SYDNEY CENTRAL CITY PLANNING PANEL

COUNCIL ASSESSMENT REPORT

Panel Reference	PPS-2018SWC103
DA Number	DA/684/2018
LGA	City of Parramatta Council
Proposed Development	<p>Concept Proposal for 14 storey mixed use (retail, office, student housing, group home and boarding house) building envelope at 99-113 Macquarie Street [Epworth House], 13 storey mixed use (church administration, community facility, student housing, group home and boarding house) building envelope at 119A Macquarie Street [Fellowship Centre], 2-6 storey basement envelope (retail, church administration and 142 parking spaces), retention and restoration of Leigh Memorial Church Building including new spire; and Stage 1 demolition of existing commercial buildings to ground level.</p> <p>The application is identified as Nominated Integrated Development for the purposes of the Water Management Act 2000.</p>
Street Address	99-119A Macquarie Street Parramatta (Lot 9 DP 702736, Lot 1 DP 626765, Lot 1 DP 628809)

Figure 19: Extract from the Civic Link Precinct requiring the setbacks for No. 119A Macquarie Street

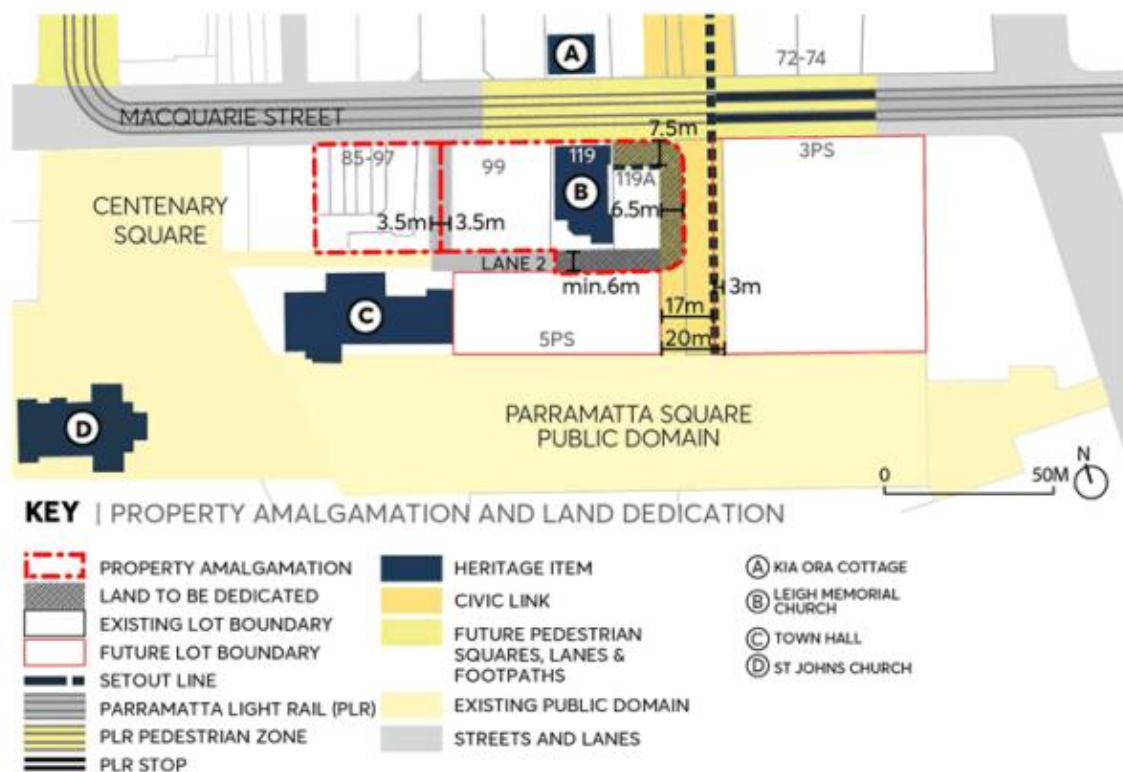
Development Control	Proposal	Comply
Amalgamation and Land Dedication		
Controls C.1, C.2, and C.3 require the subject site to provide the following buildings setbacks and land dedication, as illustrated in Figure 19 below: <ul style="list-style-type: none"> No. 119A: 7.5m setback to Macquarie Street to enable views of the Leigh Memorial Uniting Church spire, minimum 6.5m setback to the eastern 	The proposed development does not comply with the required setback, providing the following non-compliant setbacks: <ul style="list-style-type: none"> No. 119A: 5.5m (Ground-Level 2) and nil setback (Levels 3-12) to the eastern boundary, 4.93m (Ground-Level 2) and nil setback (Levels 3-12) to the southern boundary, and 9m (Ground-Level 2) and 2.95m to 6.74m setback (Levels 3-12) to the northern boundary; and 	No

The concept proposal contravenes the site specific DCP requirements under C2 of Part 4.3.3.7(m) requiring compliance with the setbacks of Figure 4.3.3.7.40 as detailed below.
